BED WALL — THE NICHE

AST-DR-034

PROJECT
A Study in Teak — Bed Wall — the Niche

DETAIL 2 - THE ENTRANCE CORNER

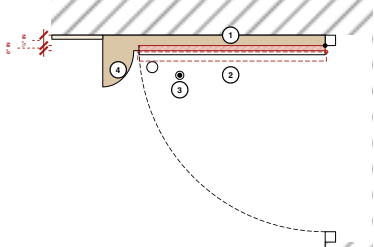
1. DOOR: the 3 in face stands 1 in proud of DT's hinge pin - the open leaf hits it (detail 2). Projecting hinges (A), or 1 in at that corner (B).
2. The bed comes 4 in further out (headboard + frame) 2 ft 6 in to left to the TV drawers instead of 2 ft 9 in.
3. The ceiling cove light along this wall: stop the build-out under it, or run the cove in the top. Your call.
4. Lamp sockets and switches go through the plaster panels - fix their places (not item 02) before the panels are made.

1. AS SKETCHED - the open leaf hits the 3 in face: its hinge pin stands only 2 in off the wall (red).
2. FIX A - projecting (particulate) hinges throw the pin out 1 1/2 in: the leaf clears and still opens flat (dashed).
3. Floor stop - keeps the knob off the veneer.
4. FIX B - 1 in at this corner instead of 3 in: ordinary hinges clear.

DETAIL 2 · THE ENTRANCE CORNER

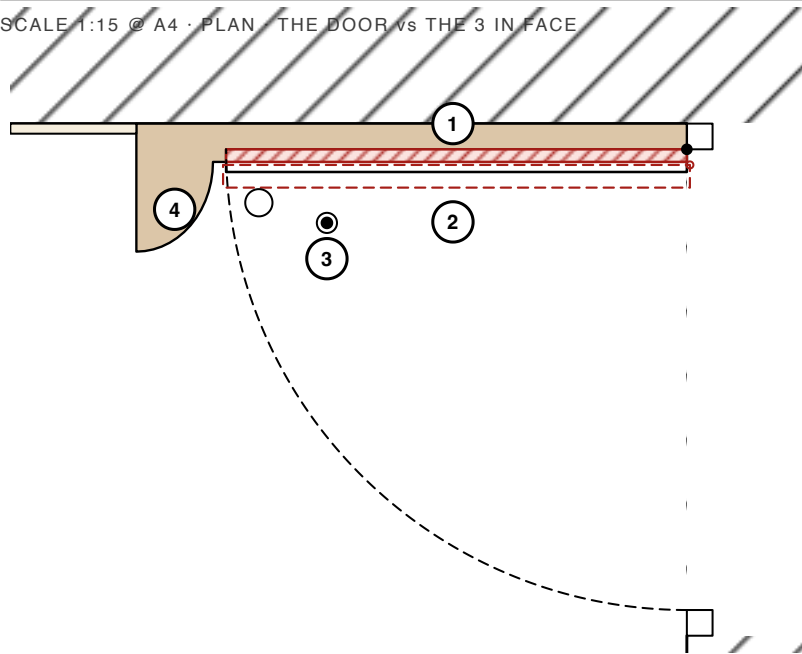
1 · DOOR: the 3 in face stands 1 in proud of D1's hinge pin — the open leaf

hits it (detail 2). Projecting hinges (A), or 1½ in at that corner (B).

- 1 AS SKETCHED — the open leaf hits the 3 in face: its hinge pin stands only 2 in off the wall (red).
- 2 FIX A — projecting (parliament) hinges throw the pin out 1¼ in; the leaf clears and still opens flat (dashed).
- 3 Floor stop — keeps the knob off the veneer.
- 4 FIX B — 1½ in at this corner instead of 3 in: ordinary hinges clear.
